**CITY OF LOS ANGELES**  
INTER-DEPARTMENTAL CORRESPONDENCE

4100 W. Sunset Bl  
DOT Case No. CEN20-50700

Subject: **UPDATED TRANSPORTATION ASSESSMENT FOR THE PROPOSED MIXED-USE PROJECT  
LOCATED AT 4100 WEST SUNSET BOULEVARD**

PROJECT SITE PLAN

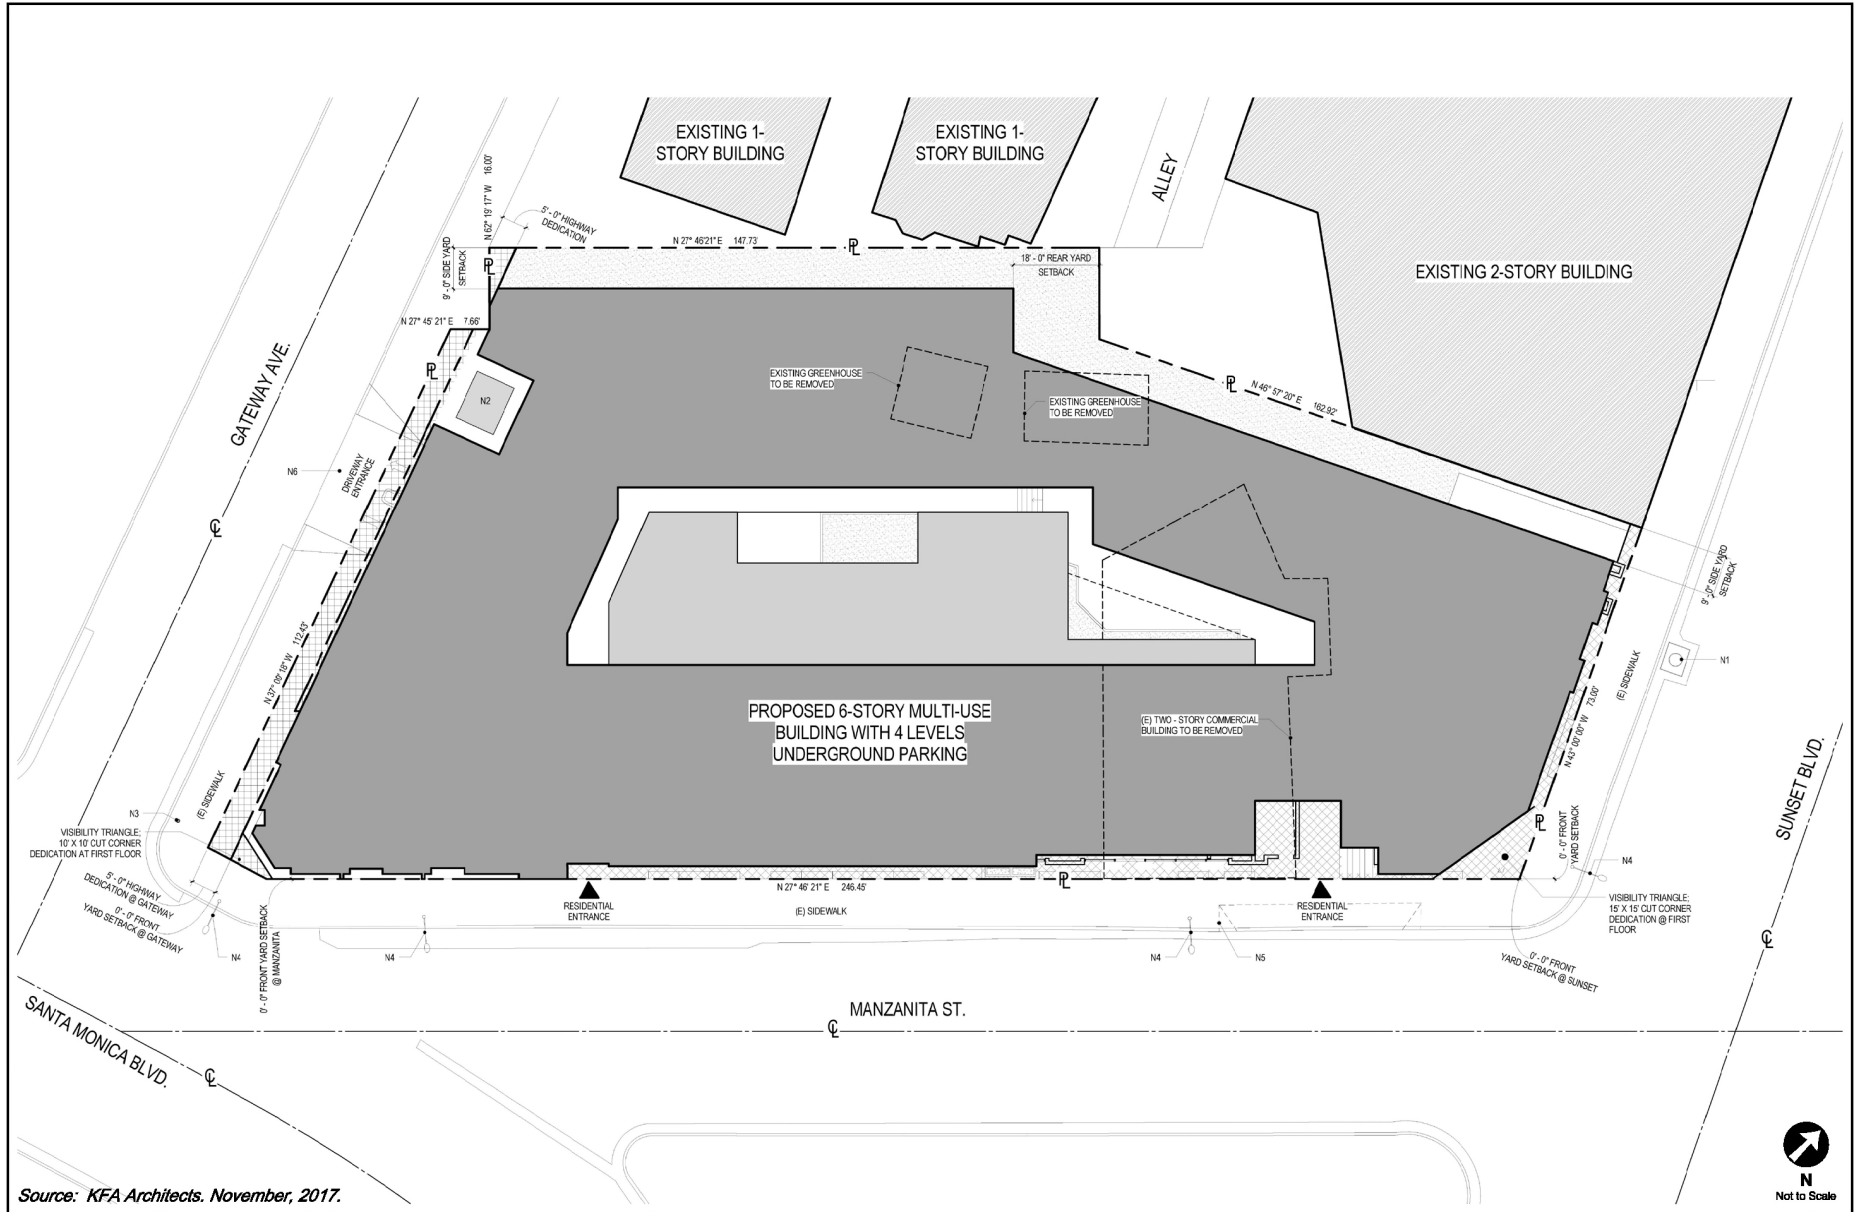
The conceptual site plans for the development (see Attachment 1) are acceptable to DOT. However, the review of this study does not constitute approval of the driveway dimensions, access and circulation schemes. Those require separate review and approval and should be coordinated as soon as possible with DOT's Citywide Planning Coordination Section (201 N. Figueroa Street, 5th Floor, Room 550, at 213-482-7024). In order to minimize and prevent last minute building design changes, the applicant should

contact DOT for driveway width and internal circulation requirements so that such traffic flow considerations are designed and incorporated early into the building and parking layout plans to avoid any unnecessary time delays and potential costs associated with late design changes. All driveways should be Case 2 driveways and 30 feet and 16 feet wide for two-way and one-way operations, respectively, and any security gates should be a minimum 20 feet from the property line. All delivery truck loading and unloading should take place on site with no vehicles having to back into the project via any of the project driveways.
